Pippita Rail Trail Active Transport Link Feedback

These comments have been prepared on behalf of CAMWEST, a Bicycle NSW affiliated Bicycle User Group with a focus on advocating for and encouraging cycling in Western Sydney.

Context Map from the Cumberland City website.

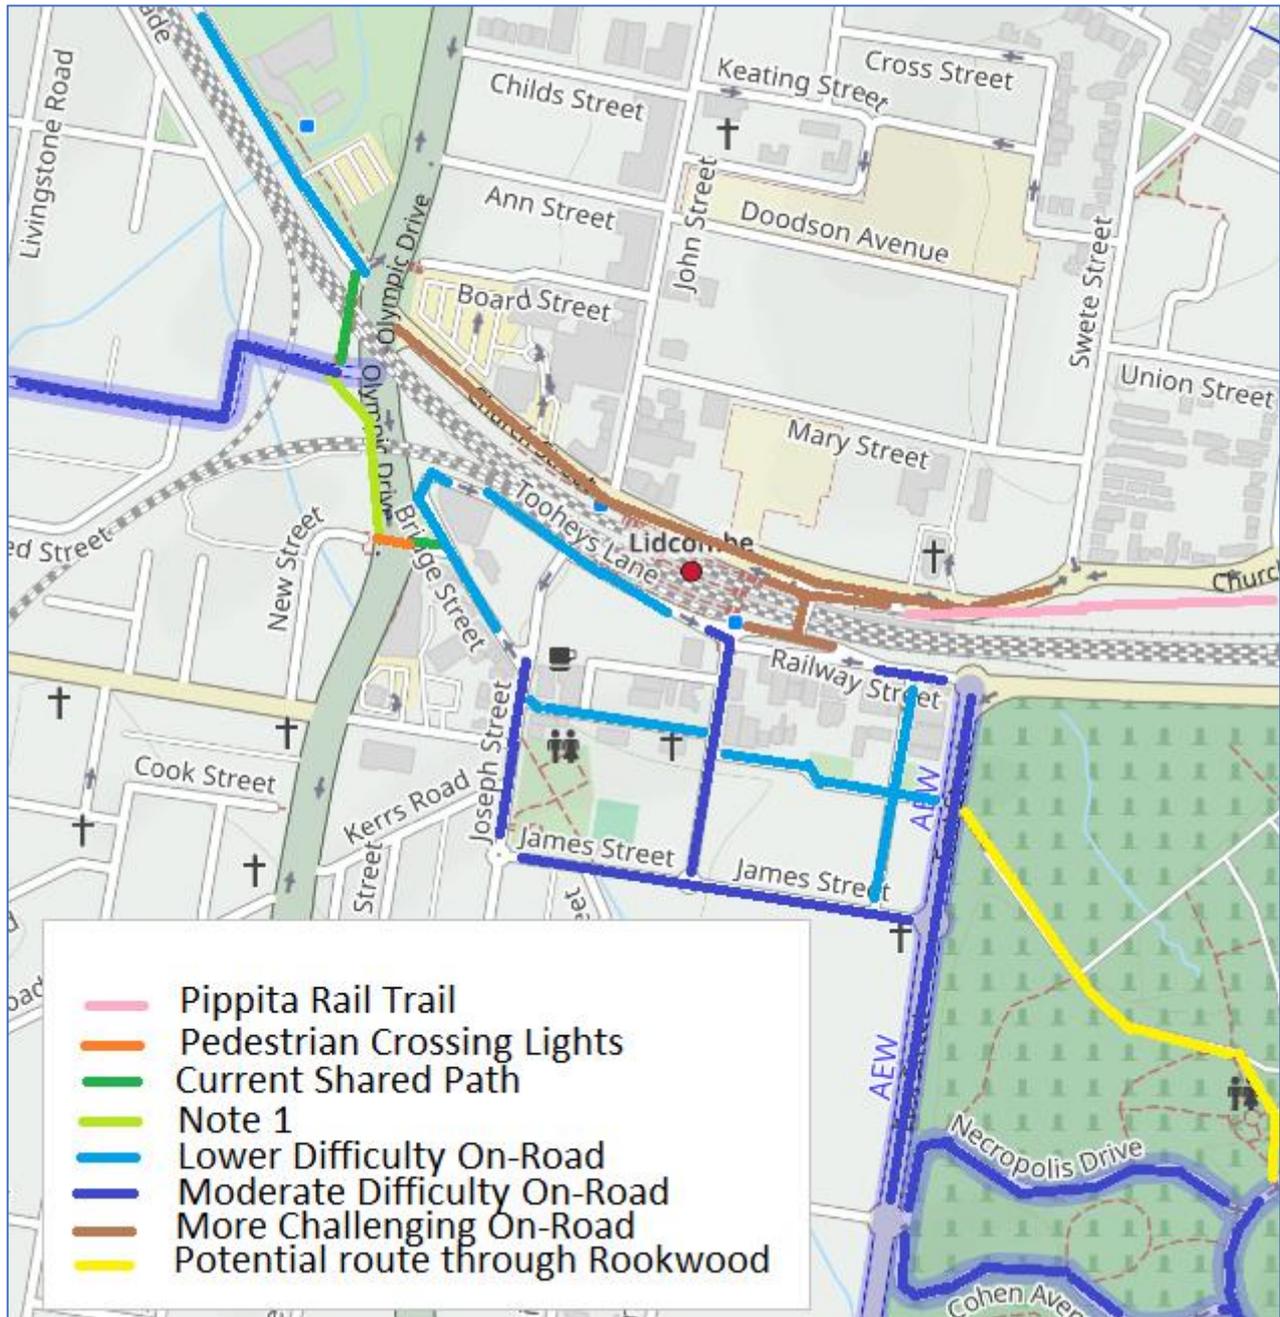
Our primary concern, however, is regarding connectivity at either end of the 2km Trail. There is insufficient detail in the above Context Map to determine precisely where the northern end of the Trail terminates. If the above route is proportionate and accurate, then it appears that the northern end may continue across Edwin Flack Avenue and into the Sydney Olympic Park Warm-Up Arena – but this is unclear.

Marked up map from RMS Cycleway Finder

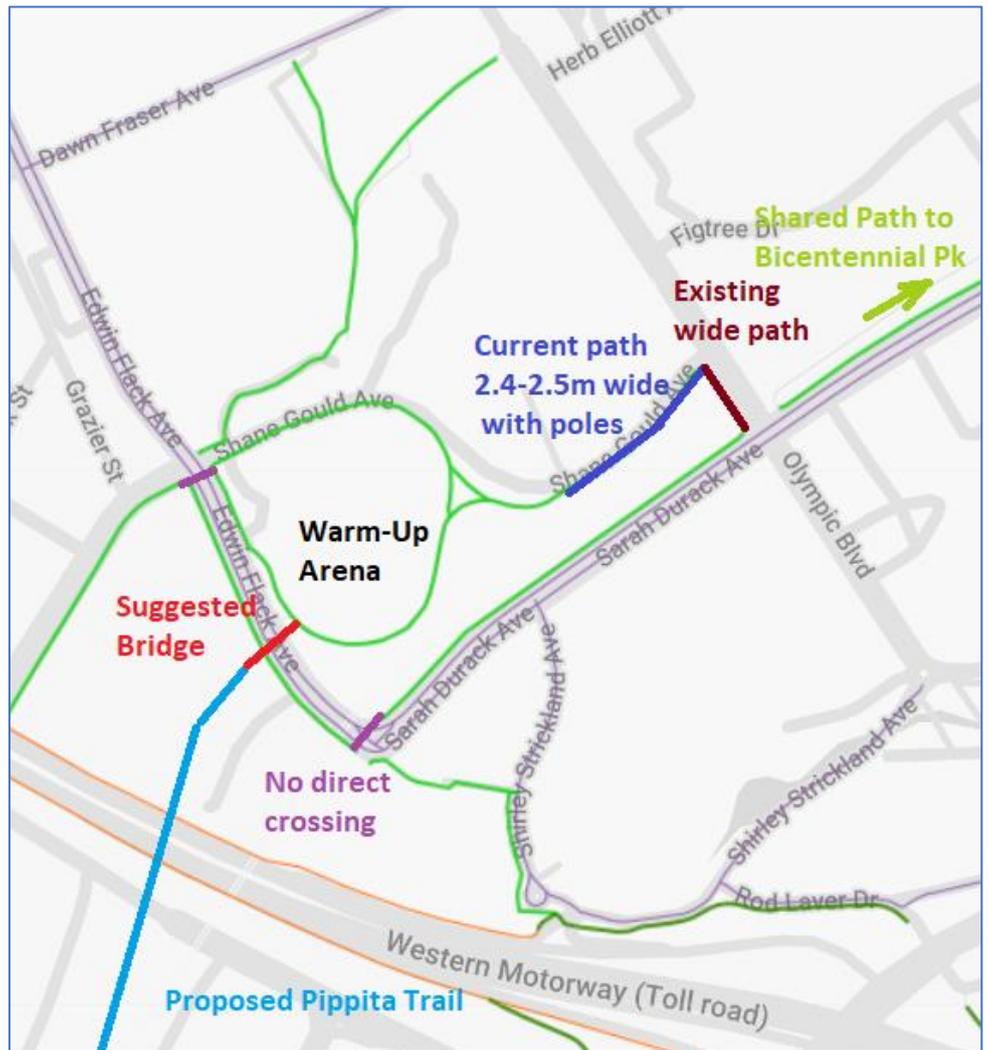
If possible, a bridge across Edwin Falck Ave to join up with the existing path around the Warm-Up Arena would be the ideal – but the existing narrow embankment along the NE side of Edwin Falck Ave may present some challenges.

If planning to use this route around the Warm-Up Arena, some of the existing path alongside Shane Gould Ave would probably need to be widened as the current path varies between 2.4 and 2.5m wide with lamp posts in the middle.

Note that the RMS Cycleway Finder page lists the SW side of Edwin Falck Ave as a shared path. As mentioned above, this path is narrower than the path on the other side of the road and has no easy crossing points.
